100/300 AREA UNIT MANAGERS MEETING APPROVAL OF MEETING MINUTES

100 & 300 AREA UNIT MANAGER MEETING MINUTES

Groundwater and Source Operable Units; Facility Deactivation, Decommission, and Demolition (D4); Interim Safe Storage (ISS); Field Remediation (FR); and Mission Completion

January 12, 2012

Subject: 100-D-30 Proposed Sampling

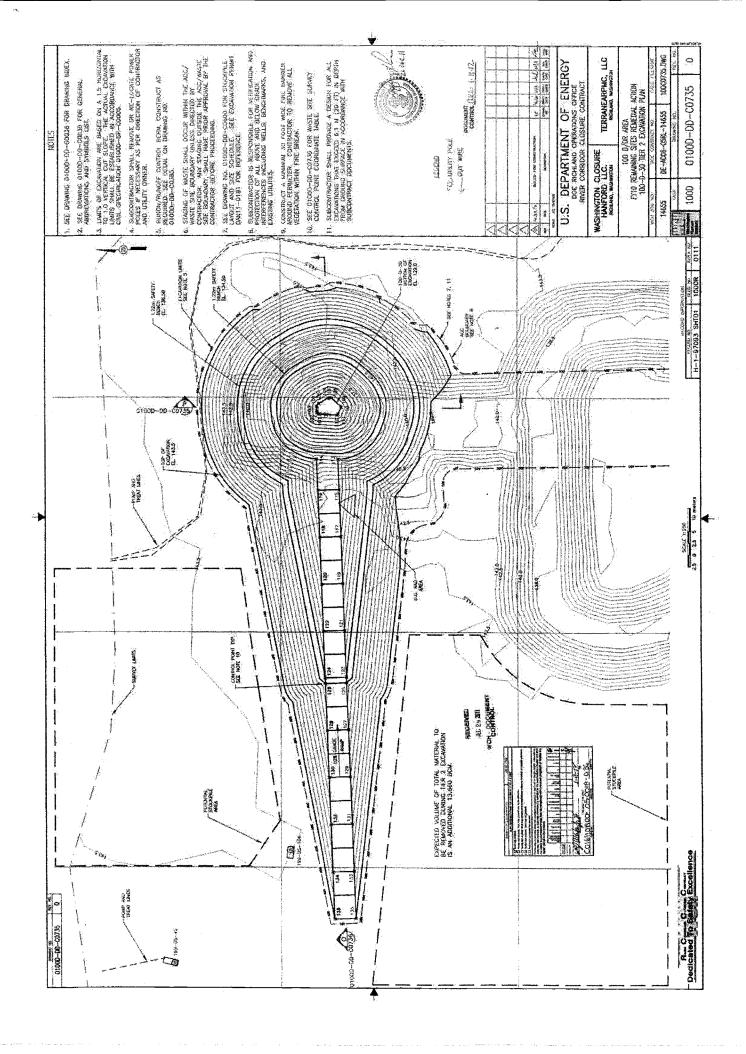
Per our discussion in today's meeting, I'd like to propose the following sampling strategy for our upcoming 100-D-30 remediation:

- · Sample at 5 foot intervals.
- At each 5 foot interval, collect three evenly spaced samples across the floor. If conditions (e.g, material sloughing) don't allow three samples to be collected, collect one composite sample of the floor.
- Analyze all samples for hex. chrom and total chrome.

My apologies - I had meant to include my approval for the staging piles as identified on drawing 0100D-DD-C0735. With regards to the number of samples, unless you can provide a reason why three samples cannot be collected, three samples should be collected.

I concur with your strategy for sampling at 5 foot intervals in accordance with the Tier 2 Excavation Plan drawing 0100D-DD-C0735. I do not see any compelling reason however why you cannot collect three evenly spaced samples at each 5 foot interval rather than one composite, making your best efforts to avoid material sloughing from the sidewalls.

Subject: 100-D-100 Tier 2 Potholes

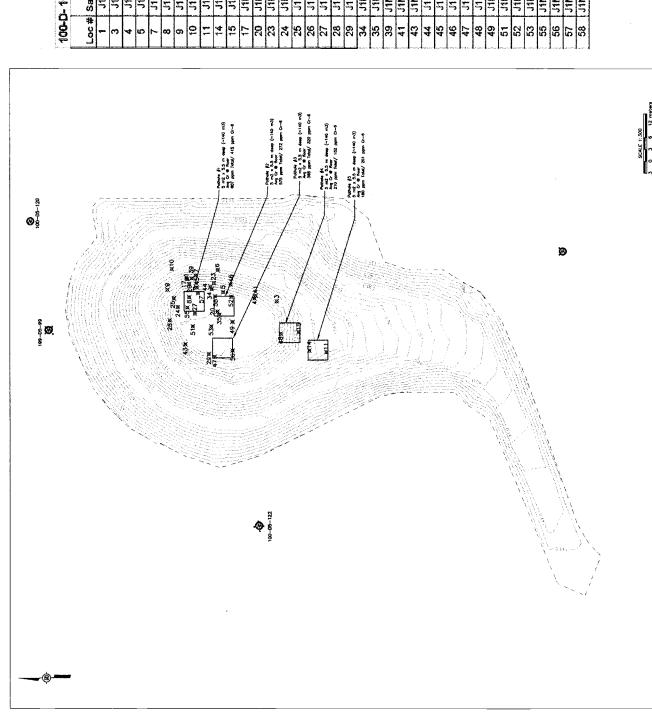
How is it going? As part of our interface meeting tomorrow, I'll be reviewing potholes we'll be digging in early January to help define Tier 3 remediation (see attached sketch). Our strategy will consist of:

- Remediating 5 potholes. Each pothole will range in depth between 15-20 feet. The five potholes were selected based on their ability to define the Tier 3 design. Although all efforts were made to pothole the highest chrome concentrations, this could be not be done in all cases because of access issues.
- For each pothole, we'll collect total and hex. chrome samples approximately every 5 feet.
- The pothole material will be returned to its original location. All the recommended pothole areas will be included in the Tier 3 design, which means they will be remediated and stockpiled. The basis for backfilling the potholes is to provide a foundation for our equipment to perform Tier 3 remediation.
